Permit Number: 071311

has permission to New Master Bedroom & Storage Addition

City of Portland, Maine - Building or Use Permit Application

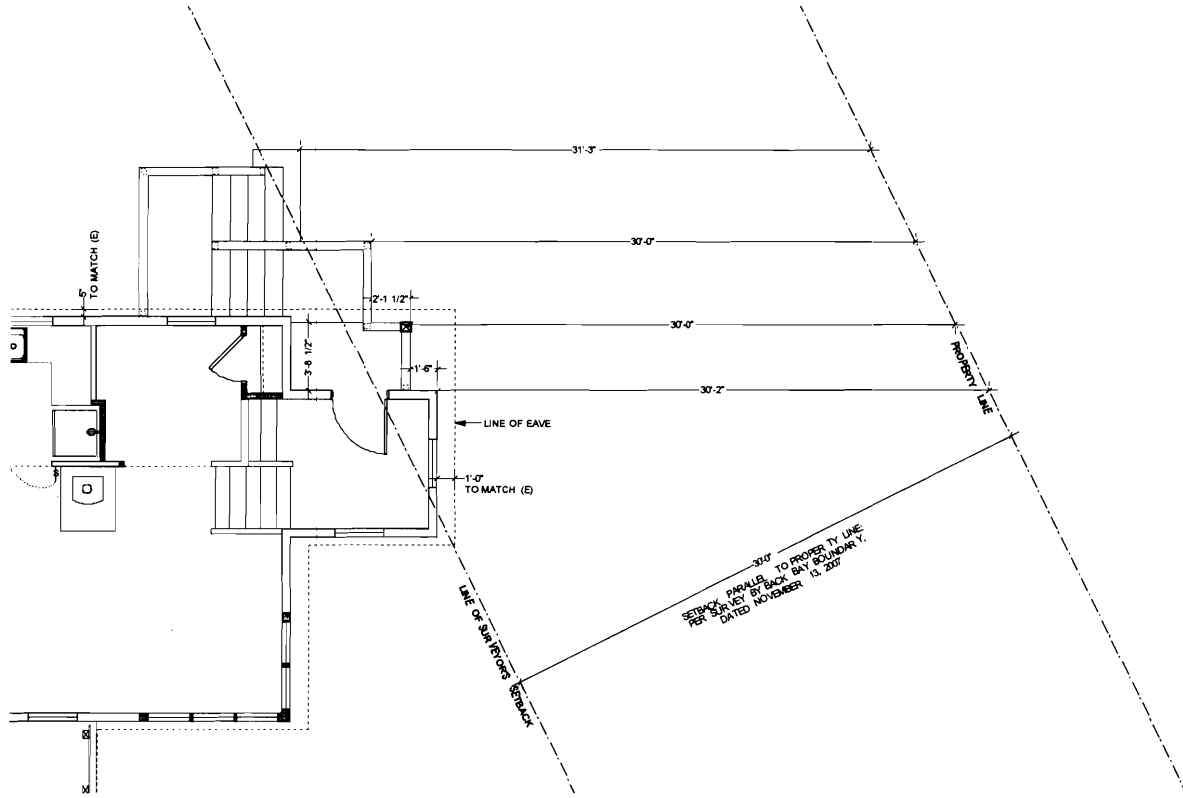
> Diane-
>
> From what I can see on the sketch, it looks like the setbacks would be
> met. Of course until I get a final plan submitted I can't make a final
> determination.
>
> Thanks, Ann
>
>>>> Diane Martin <dmartin@bdearch.com> 11/19/2007 4:40:14 PM >>>
> Hello Ann,
>
> Here is the sketch we discussed over the phone this morning. Thank you
> for
> taking a look at it. I just want to make sure we are totally on the
> same
> page in understanding what we can build on this site and where we can
> build
> it.
>
> If this meets your approval, we will finalize the revisions to the
> drawings
> and submit them to you for your official review as soon as possible.
>
> We look forward to hearing from you.
>
> Thank you for all your help.
>
> Diane.
>
> Diane Martin
> Architect
> BDE ARCHITECTURE
> 465 California Street, Suite 1200
> San Francisco, CA 94104
>
> Tel: 415.677.0966 Ext. 335
> Fax: 415.677.0964
>
> dmartin@bdearch.com
> www.bdearch.com
